AGREEMENT NO. CE 31/95
ENVIRONMENTAL IMPACT ASSESSMENT STUDY FOR
PWP ITEM NO. 437CL:
"ALDRICH BAY RECLAMATION - ENGINEERING WORKS"

ENVIRONMENTAL IMPACT ASSESSMENT FINAL REPORT

**Environmental Impact Assessment
Final Report
January 1997**

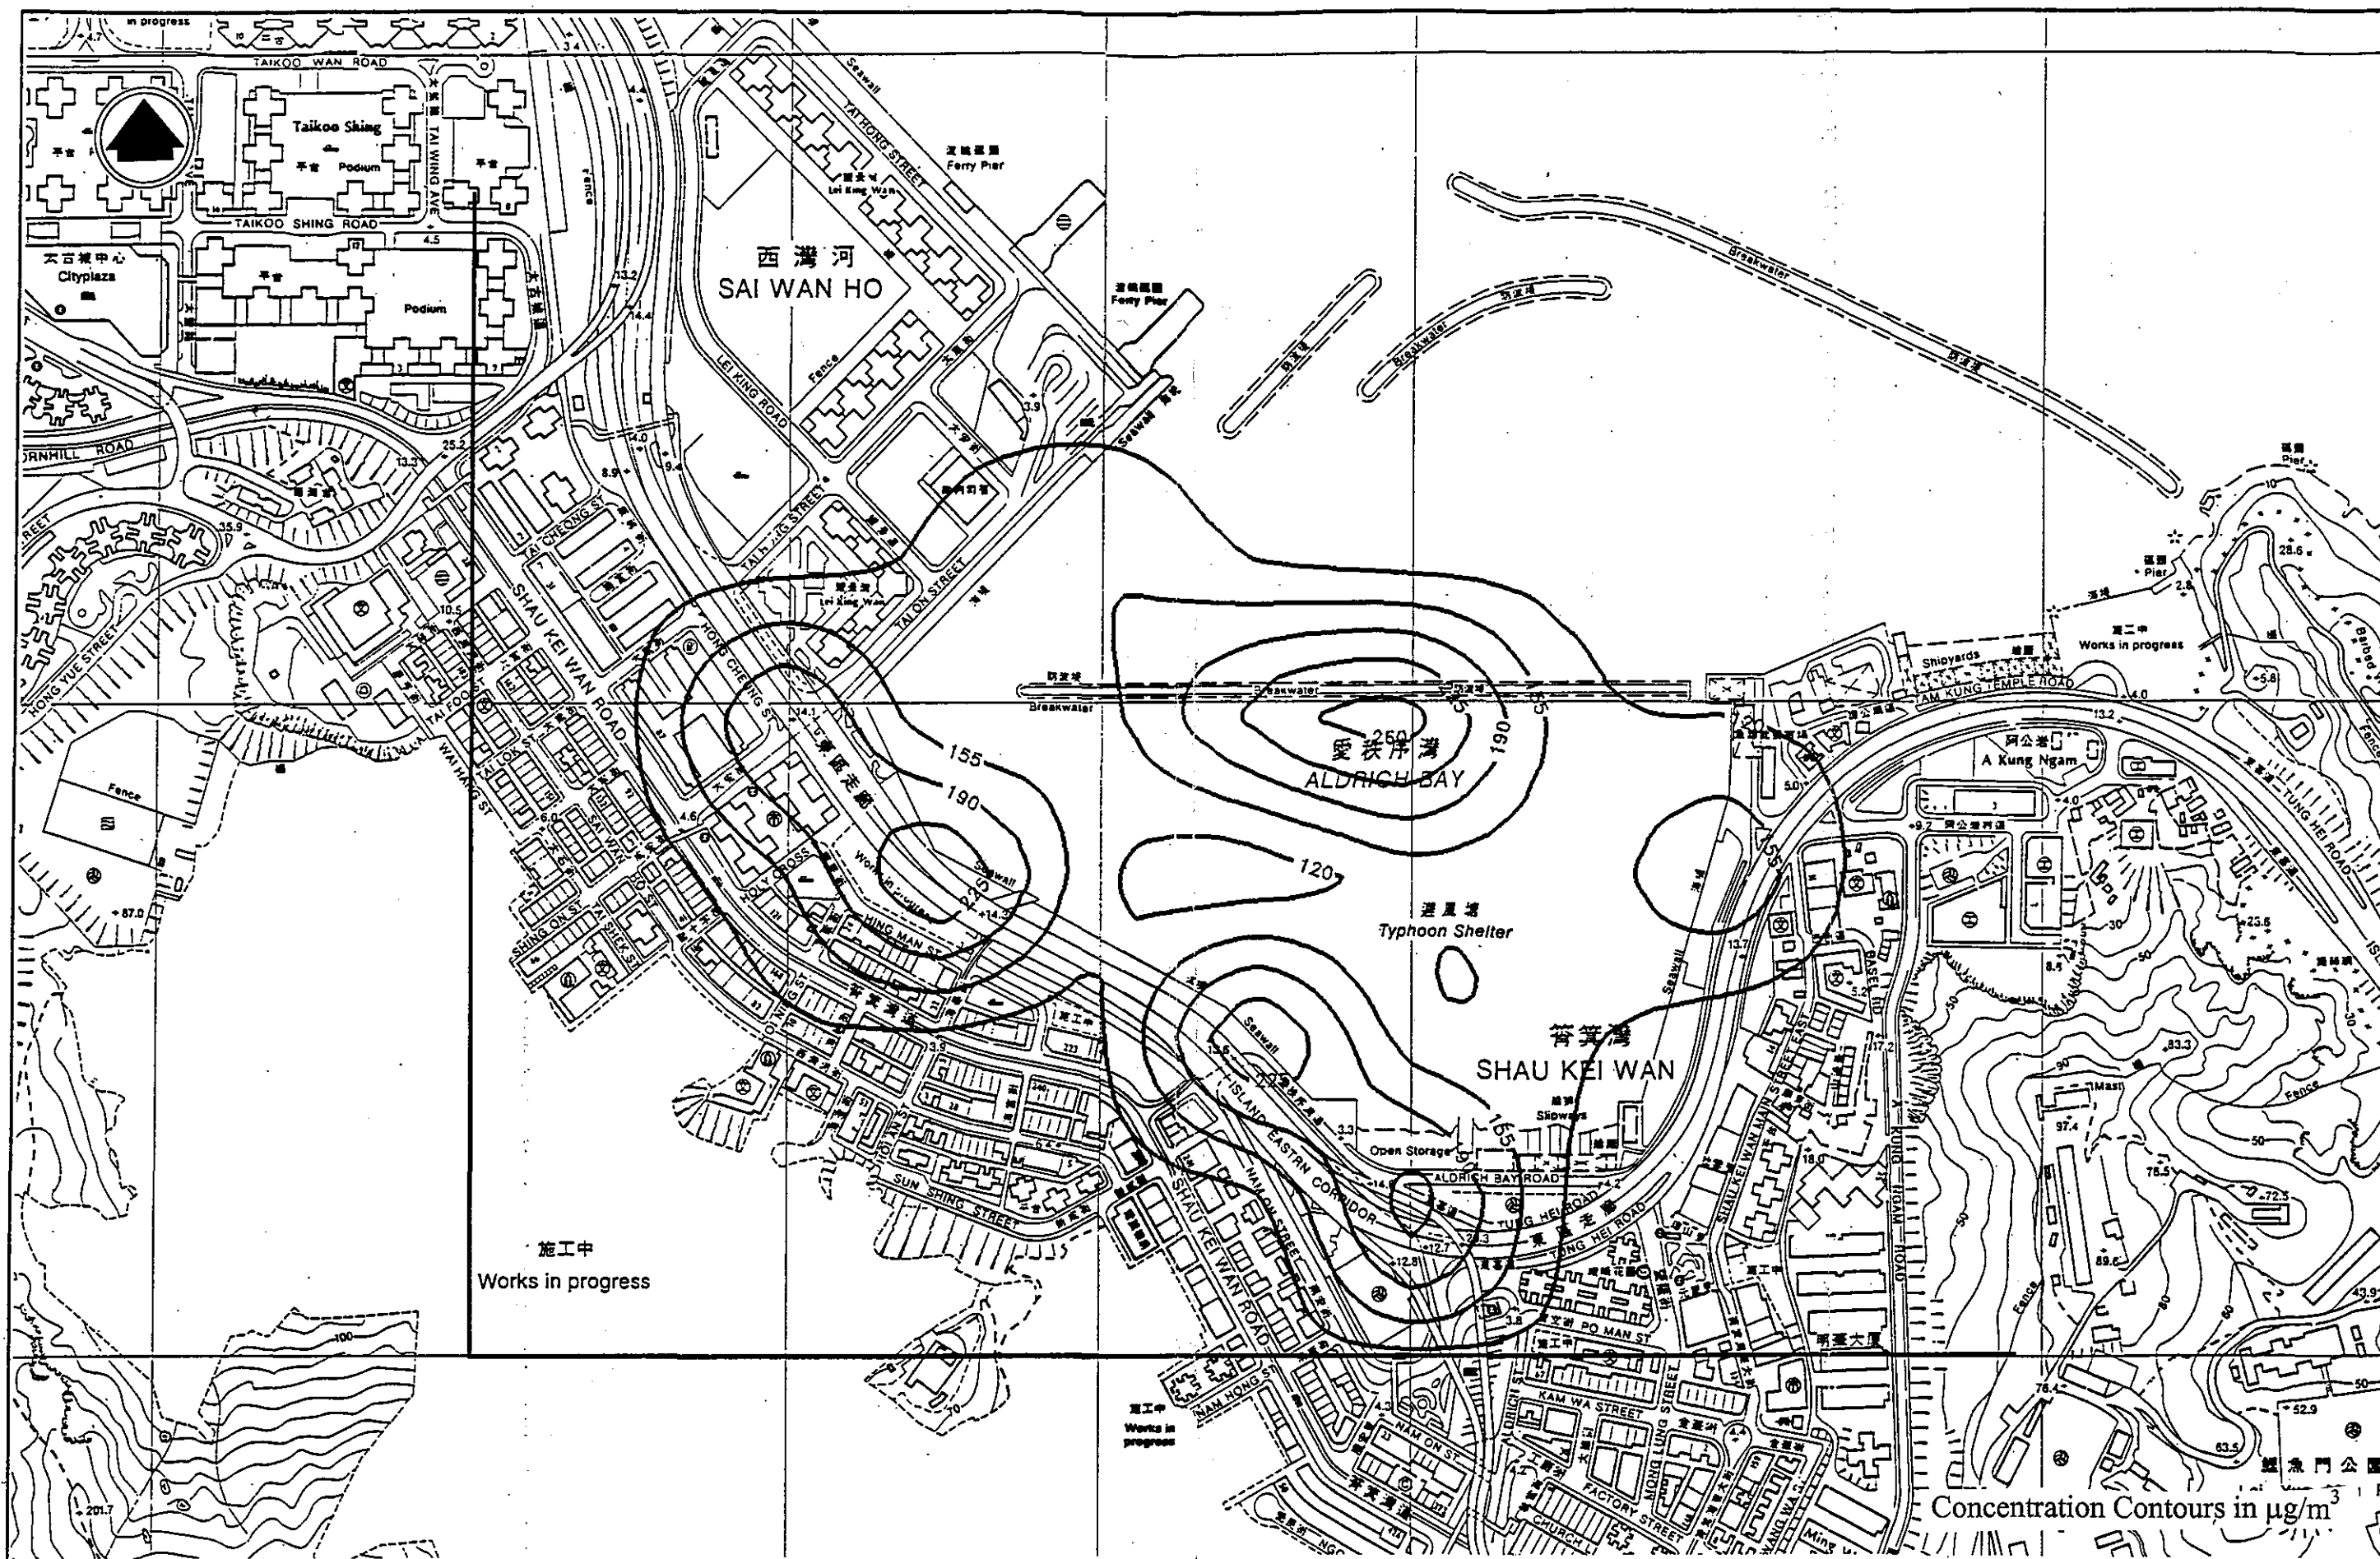
<p>c) Figure 5.8 presented the cumulative 1-hour TSP level arising from Sections II, III, IV, V (mitigated), which shows that there is no exceedance of 1-hour TSP level. However, the mitigated 1-hour TSP level due to construction work in Section II & III alone (Figure 5.4) shows the 1-hour TSP level exceeds the 1-hour TSP guideline level at some air receptors. It seems that the cumulative dust impact due to Section II, III, IV, V should also exceed 1-hour TSP guideline level if the impact due to Section II & III already exceeds the guideline level. Would the Consultants clarify?</p> <p>d) In previous submissions, contours of 24-hour TSP levels for both mitigated and unmitigated conditions are given. However, in this submission, contours of 24-hour TSP levels for both mitigated and unmitigated conditions are not given. In any case, 24-hour TSP level contours should also be plotted.</p> <p>e) The Consultants should justify why the meteorological data from Tseung Kwan O meteorological station are better than from the Hong Kong International Airport for the study area.</p>	<p>Same as 2.1(b)</p> <p>24-hour TSP concentration contours will be included in the Final Report.</p> <p>The meteorological station of Hong Kong International Airport is located in an open field where wind blows over a relatively uniform surface (i.e. harbour and runway) over a long fetch. As a result the wind exhibits relatively smaller variation in the wind speed and direction. The wind data therefore represents more of the general wind conditions in the Lei Yue Mun channel and the runway than an urban area. However, as EPD is probably aware, surface wind varies considerably over the man-made topography. The bulk of the Aldrich Bay Reclamation and, in particular, the locations of the existing receivers are sheltered from the harbour. It is highly unlikely that the historical wind condition at the runway has any resemblance to that on the reclamation and at the ASR locations because of the presence of man-made topography at the time when the proposed engineering works and the housing development are in progress. In comparison, the wind data from Tseung Kwan O is more representative of the wind condition on the reclamation because of similar isolated low- and high- rise man-made topography than the runway.</p>
